# JABIRU AIRCRAFT PTY LTD

## SERVICE BULLETIN: JSB 012-7

Issue: 7

Subject: Jabiru Engine Flywheel Attachment

Figure 2 - Plain washers compared to Nordloc washers

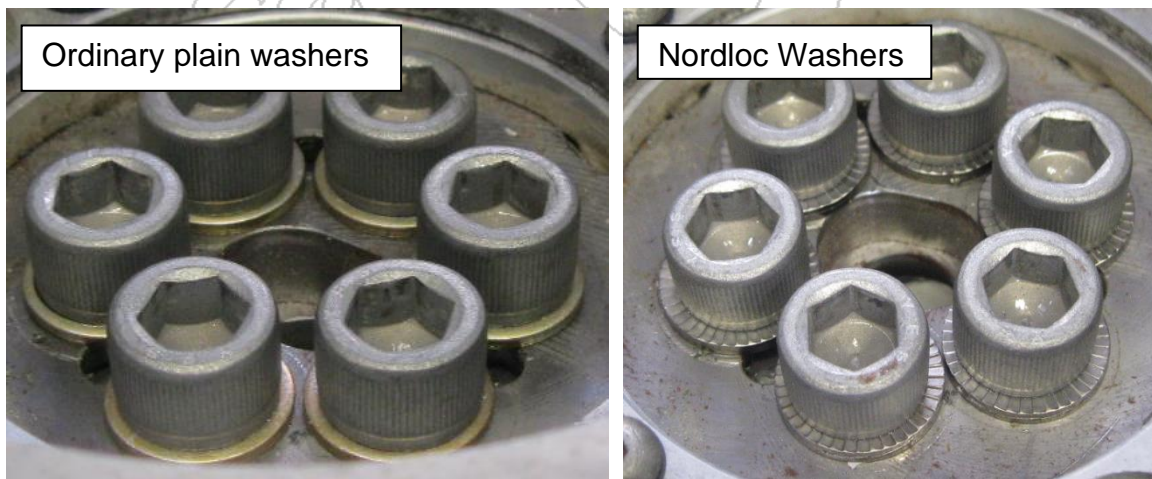
Flywheel screws must now be installed using Nordloc washers (replacing the previous installation which used either plain or Belleville washers). Jabiru engines of any and all flywheel configurations (as defined in Table 1) should now use Nordloc washers. These washers are easily identified via visual inspection as shown below in Figure 2.

Refer to the Jabiru Engine overhaul manual JEM0001 (always check for the latest revision) for the installation procedure of flywheel capscrews using Nordloc washers. The major difference in installation is that bolts installed with Nordloc washers **must not be installed with Loctite**. The torque setting is also different for capscrews installed with these washers.

When Nordloc washers are used on an aluminium surface a steel plate must be used to protect the aluminium surface. These are available from Jabiru.
